Tyres: Regulation No. 54**Proposal for a Supplement to Regulation No. 54 ((Tyres for commercial vehicles and their trailers))****Submitted by the experts from the European Tyre and Rim Technical Organisation***

The text reproduced below was prepared by the experts from the European Tyre and Rim Technical Organisation (ETRTO) amending UN Regulation No. 54. It is a consolidated Text of UN Regulation No. 54 and it includes the proposal contained in ECE/TRANS/WP.29/GRRF/2018/5.

Regulation No. 54

Arrangement of tyre markings

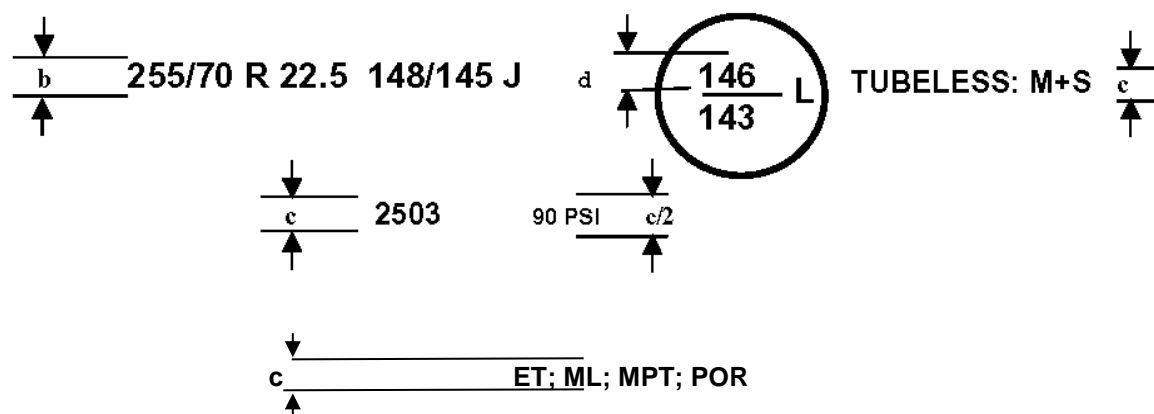
(*) PSI marking instead of kPa is allowed for tyres first type approved before 1 January 2018.
